# Work Order ID 79711

Item Name: Replacement Skidtube

DRAWING NO. D2580	TITLE 205 SKIDTUBE ASSEMBLY	REV. E	DART AEROSPACE LTD ENGINEERING ORDER		D.E.O. NO. D2580-E-1	SHEET NO. SHEET 1 OF 1	SCALE NTS
DRAWN <i>UP</i>	CHECKED <i>ASS</i>	MFG. APPR. <i>ER</i>	APPROVED <i>[Signature]</i>		DE APPR. <i>[Signature]</i>		
DATE 11.12.13	DATE 11.12.13	DATE 11.12.13	DATE 11.12.13		DATE 11.12.13

CHANGE ALL C'BORED WELDED CROSSBOLT SPACERS TO SWAGED SPACERS

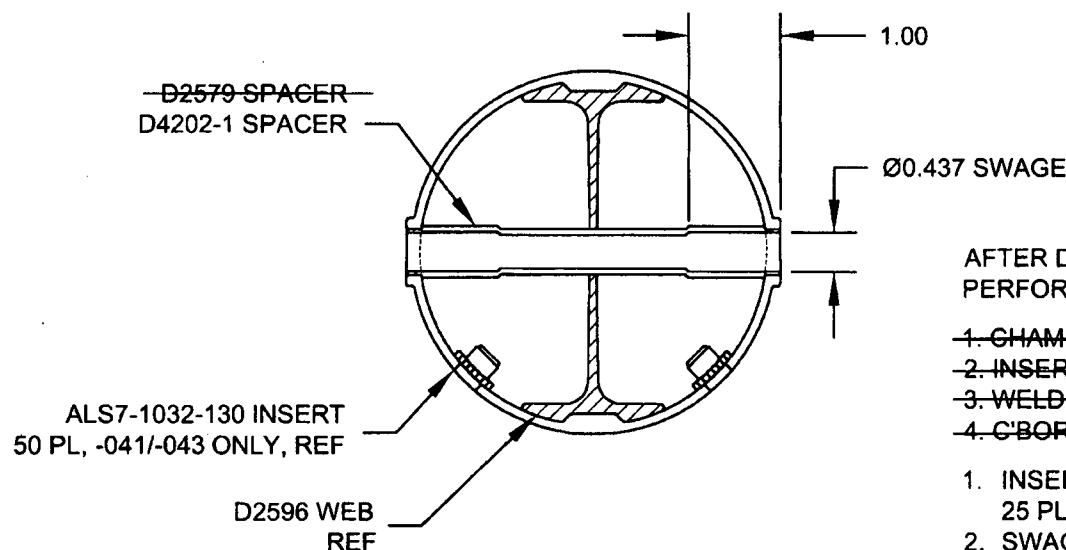
PARTS LIST IS AMENDED AS FOLLOWS:

**WAS**

QTY	QTY	QTY	PART NUMBER	DESCRIPTION
-041	-045	-047		
20	24	25	D2579	CROSS BOLT SPACER

**IS**

**\* FOR -045 SKIDTUBE ONLY:**  
WELD 4X D2579 SPACERS PER DWG  
IN LOCATIONS MARKED "NO C'BORE".  
REF SHEET 4 OF DWG.
